TECHNICAL BULLETIN

11/14

G/E401 & G/E402 & F Variant Fryer Controls Wiring Modification

Fig 1.

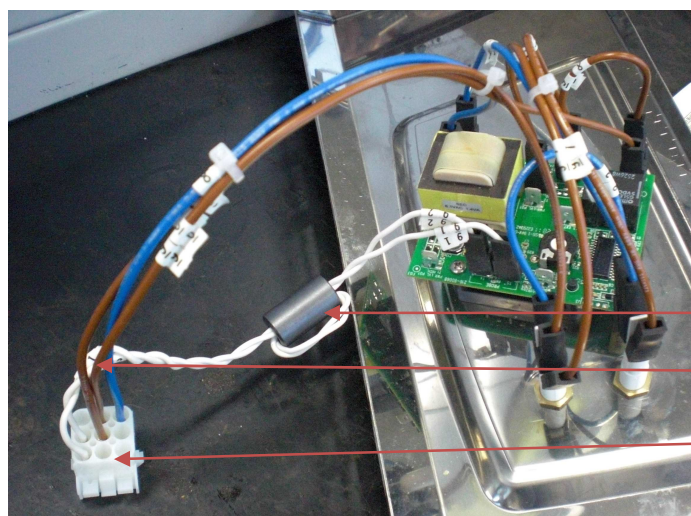
In order to reduce possible mis-operation* of the FAST controllers fitted to the above named fryers, a ferrite bead has been added in the controls wiring loom as shown below.

E & G401 & F variants FAST controller showing loom with probe wires twisted and ferrite bead added.

Ferrite Bead

Wires 91, 92, 95,
96 & 81

Replacement loom spare part number for G or E401 & 401F: 536300043.

Available as replacement kit. See spares number above.

Fig 2.

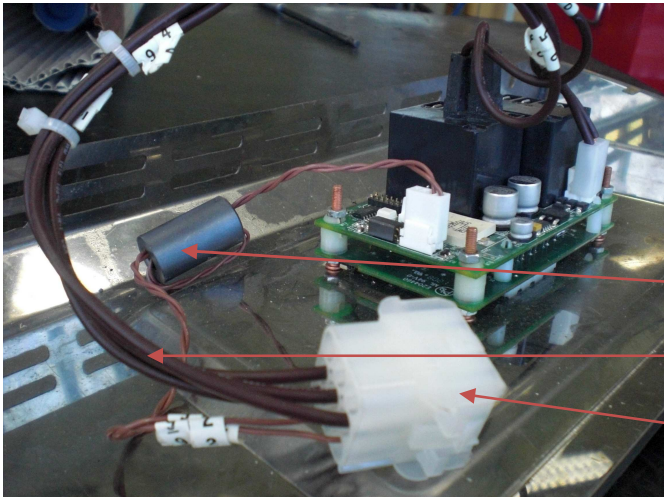
E & G402 & F variants FAST controller showing loom with probe wires twisted and ferrite bead added.

Ferrite Bead

Wires 91, 92, 93,
94, 95 & 96

Replacement loom spare part number for G or E402 & 402F: 536300044.

Available as replacement kit. See spares number above.
